To: Bassett Creek Watershed Management Commission
From: Barr Engineering Co.
Subject: Item 5B – Consider Approval of 90% Plans for Crane Lake Improvement Project (CL-1) via Ridgedale Drive – Minnetonka, MN
Date: May 8, 2019
Project: 23/27-0051.45 2019 640

5B. Consider Approval of 90% Plans for Crane Lake Improvement Project (CL-1) in Minnetonka

Recommendations: Conditional approval of 90% Plans

Figure 2: Subwatersheds Served by Ridgedale Drive Drainage System

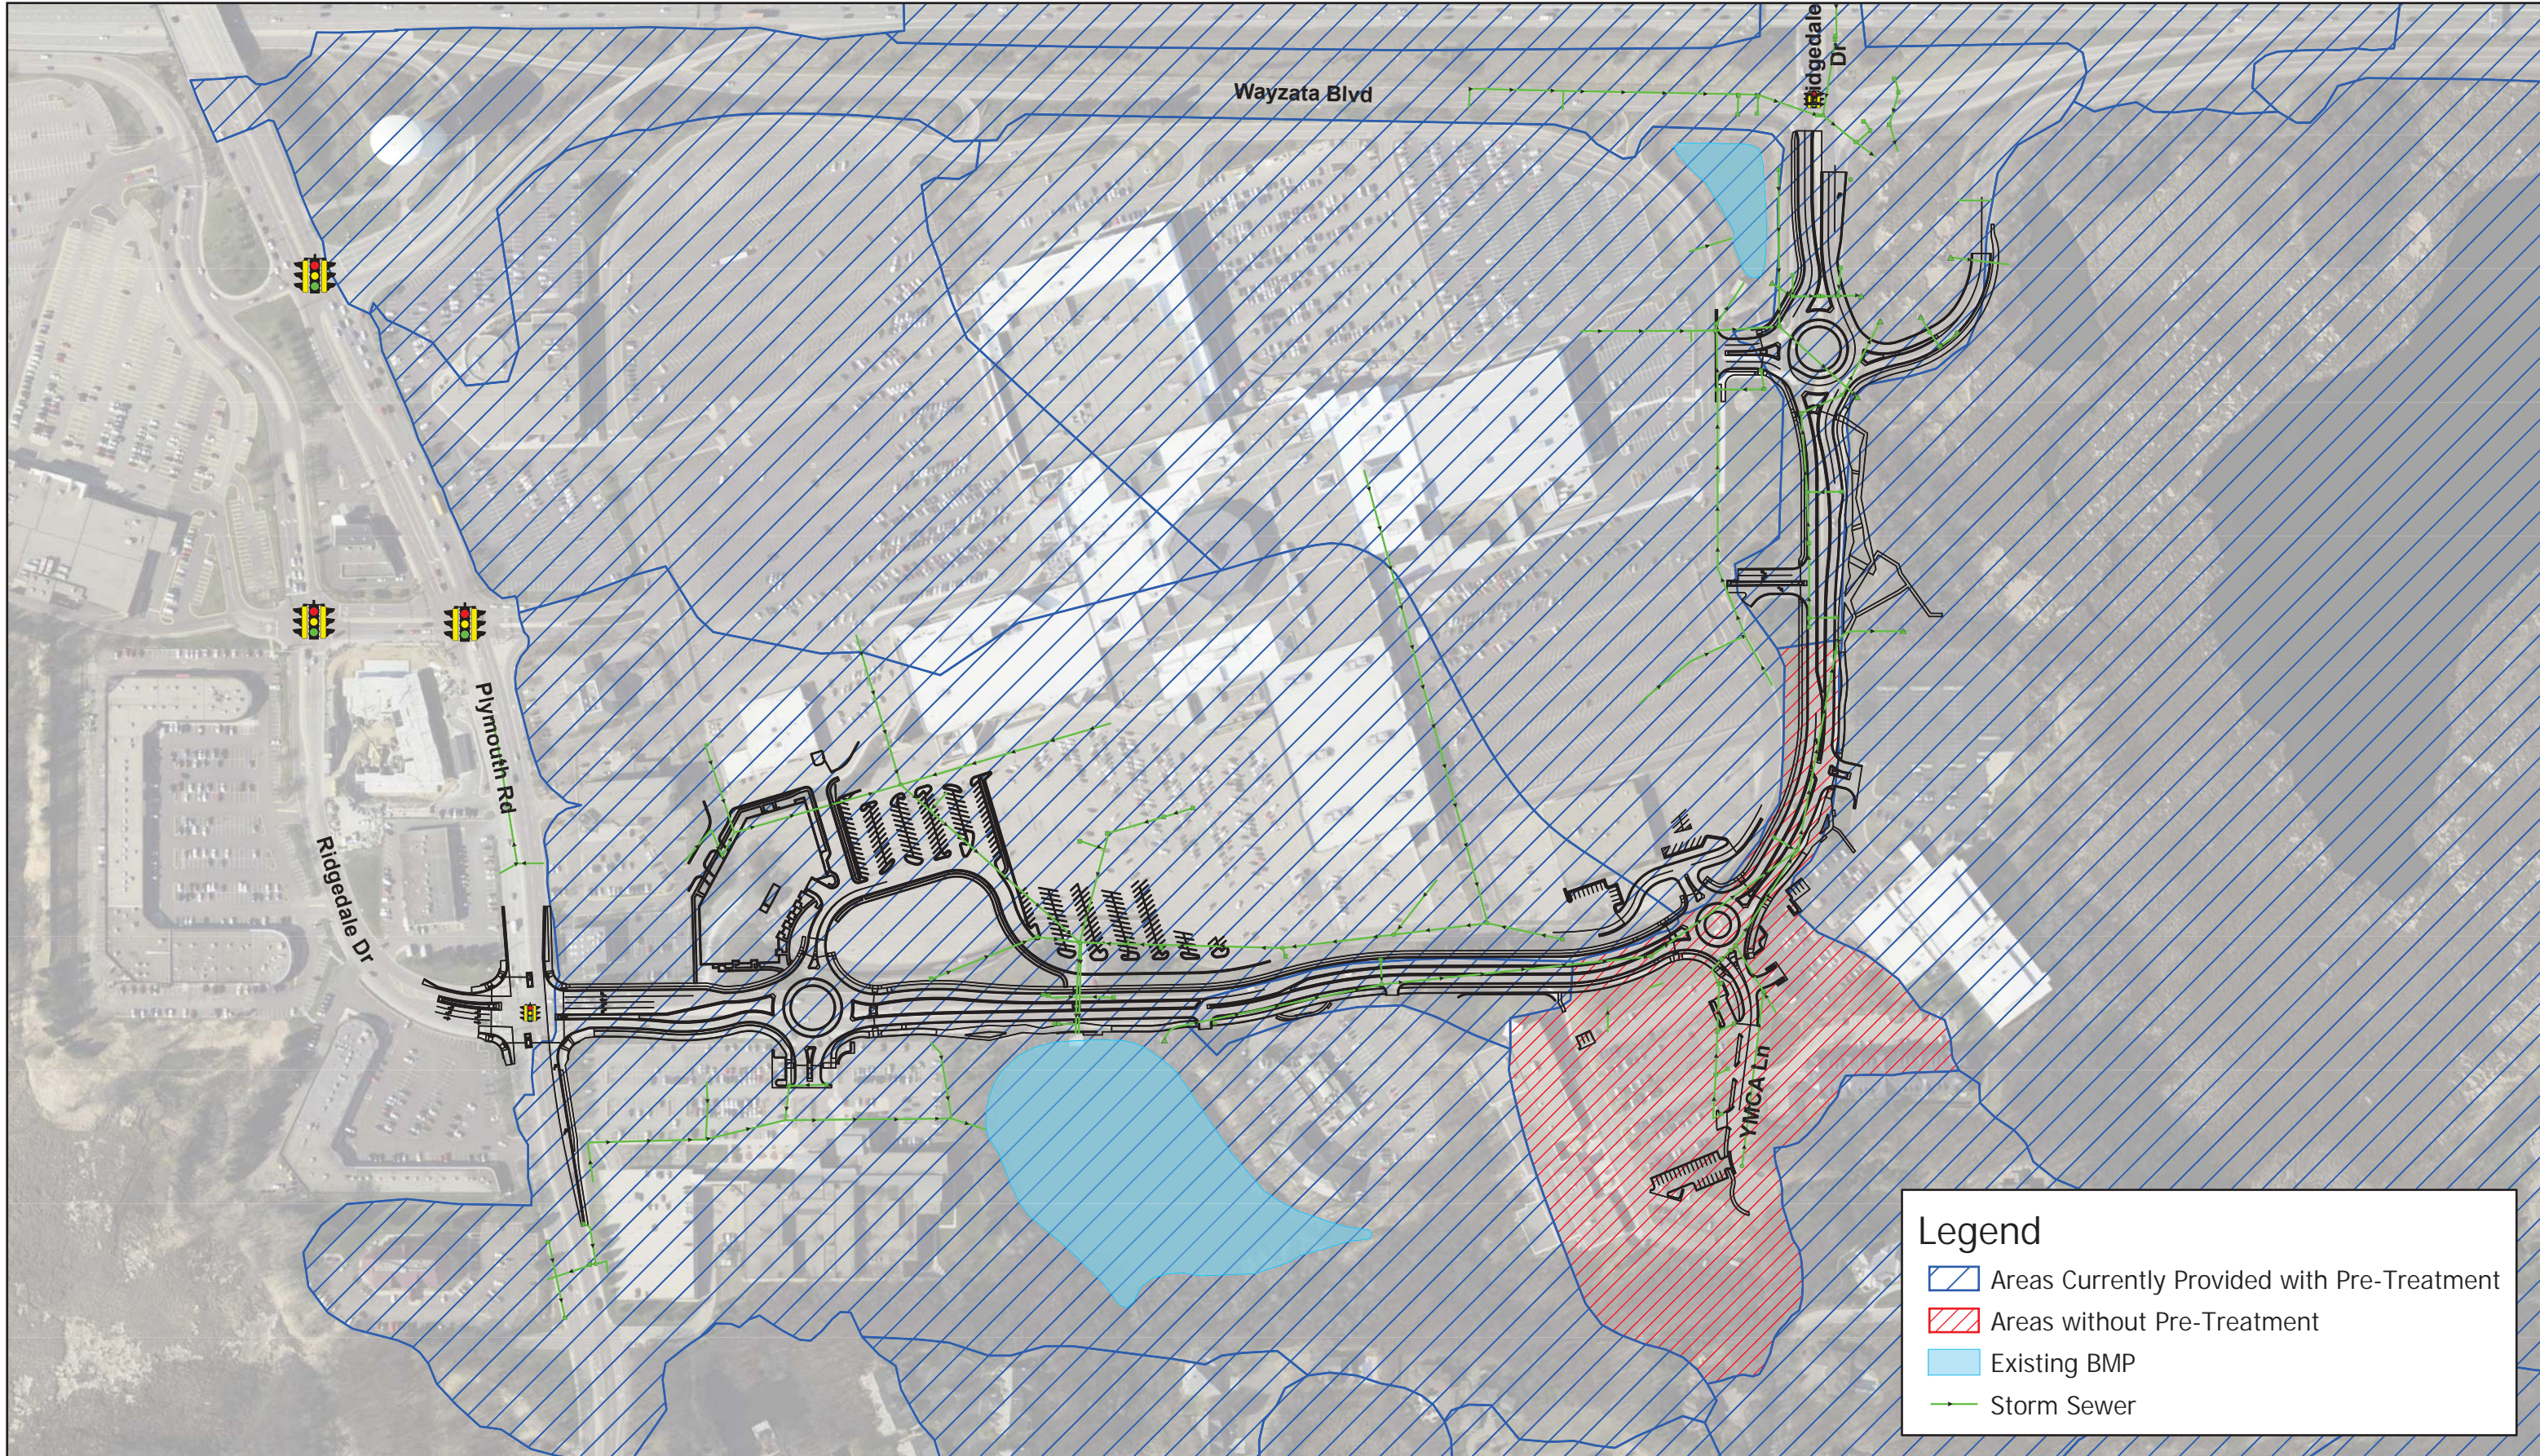
At their March 21, 2019 meeting, the Commission reviewed the City of Minnetonka's feasibility study (*2020 Crane Lake Improvement Project (Water Quality Improvements to be Incorporated into the 2019 Ridgedale Drive Reconstruction Project)* (WSB, February 22, 2019; updated March 14, 2019)), which examined the feasibility of water quality improvement alternatives to treat runoff from Ridgedale Drive and the Sheraton Minneapolis West Hotel parking lot before discharging to Crane Lake (see red-hatched area on attached Figure 2 from the feasibility study).
